Project Name: Flagler Residences

Subject: WATER AND WASTEWATER CAPACITY AVAILABILITY LETTER

Flagler Residences – DRC Case No. USP-S21059 513-517 NE 6th Street, Fort Lauderdale, Fl 33304

City of Fort Lauderdale Public Works Department Water and Wastewater Capacity Analysis

Figure 1 - City Water Atlas

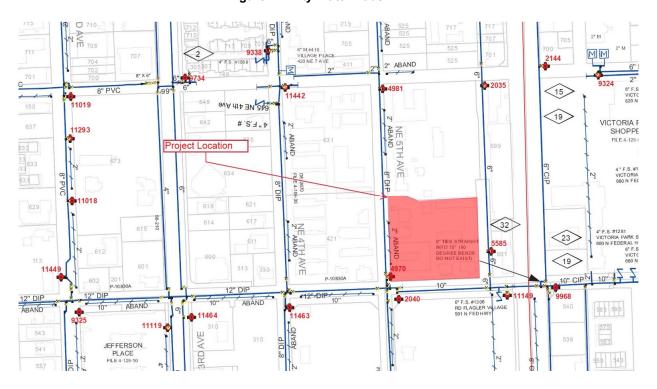
Water: The site is currently served by a 6-inch water main along NE 5th Terrace, a 10-inch water main along NE 6th Street, and an 8-inch water main along NE 5th Ave. See Figure 1.

Evaluation of impact on existing distribution pipe: According to the site plan, the applicant is proposing to utilize the 6-inch water main along NE 5th Terrace, a 10-inch water main along NE 6th Street, and an 8-inch water main along NE 5th Ave. The InfoWater hydraulic model was analyzed to determine the impact of this project on the existing water main infrastructure.

Recommended Water Infrastructure Improvements: No improvements required.

Figure 3

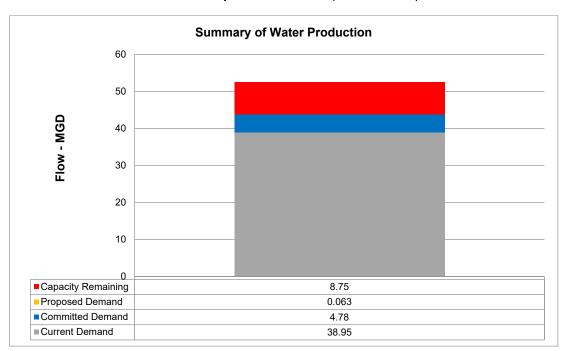
Evaluation of impact of Permitted Water Plant Capacity: The Fiveash and the Peele Dixie Water Treatment Plants are designed to treat 70 MGD and 12 MGD of raw water respectively (82 MGD total). The total permitted Biscayne aquifer water withdrawals for these plants is limited to 52.55 MGD per the South Florida Water Management District (SFWMD) permit number 06-00123-W.

The current twelve-month rolling average production at the two plants is 38.70 MGD. The previously committed demand from development projects in the permitting or the construction stage is 4.78 MGD. Combining these figures with the demand from the proposed project of 0.0632 MGD, the required production would be 43.55 MGD. This is less than the allowable withdrawal limit of 52.55 MGD. Therefore, the water plants have sufficient capacity to serve this project. See Figure 3 below.

Figure 4

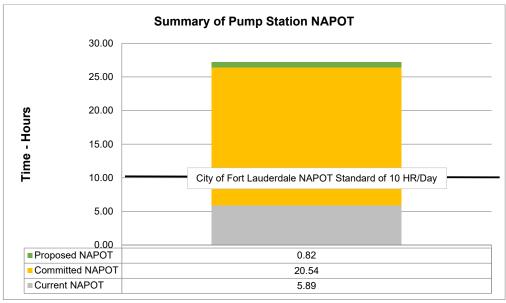
Evaluation of impact on pumping station: PS A-21 has a duty point of 978 gallons per minute (GPM) and has a Nominal Average Pumping Operating Time (NAPOT) of approximately 5.89 hours per day. Based on projected sewage flows, the pumping run times would increase approximately 49 minutes per day. Additionally, there are other committed flows from proposed developments within the PS A-21 basin resulting in 1232.32 minutes of additional runtime. PS A-21 will have a NAPOT of 27.25 hours once the proposed developments are complete, more than the recommended average of 10 hours per day. See Figure 4.

The City's Pump Station Flagler Village A-24 is a major initiative within this basin to reduce the amount of flow handled by the existing PS A-21 and to provide additional capacity within this area. Once PS A-24 is constructed and on-line, there will be sufficient capacity at this new pump station to convey the estimated wastewater demand from the development to the treatment plant.

Recommended Wastewater Infrastructure Improvements: PS A-21 does not have sufficient capacity to handle the proposed development. The proposed PS A-24 shall be constructed and on-line prior to the proposed development seeking a Certificate of Occupancy.

Figure 5

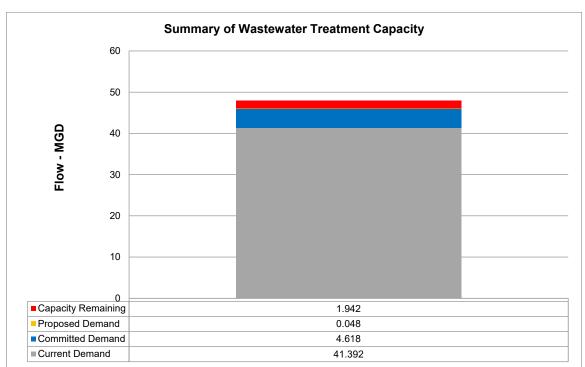
Evaluation of impact of Permitted Wastewater Plant Capacity: The City of Fort Lauderdale owns and operates the George T. Lohmeyer Regional Wastewater Treatment Plant (GTL), which provides wastewater treatment for the City of Fort Lauderdale. The Broward County's Environmental Protection and Growth Management Department's (EPGMD) Environmental Licensing & Building Permitting Division's licensed capacity for GTL is 48 MGD-AADF (Million Gallons per Day – Annual Average Daily Flow). The annual average daily flow (AADF) to the plant is 41.39 MGD. Combining the committed flows for previously approved projects of 4.62 MGD plus the 0.0479 MGD net contribution from the project results in a total projected flow of 46.06 MGD. This is less than the permitted treatment plant capacity of 48 MGD. Therefore, the treatment plant has sufficient capacity to serve this project. See Figure 5 below.
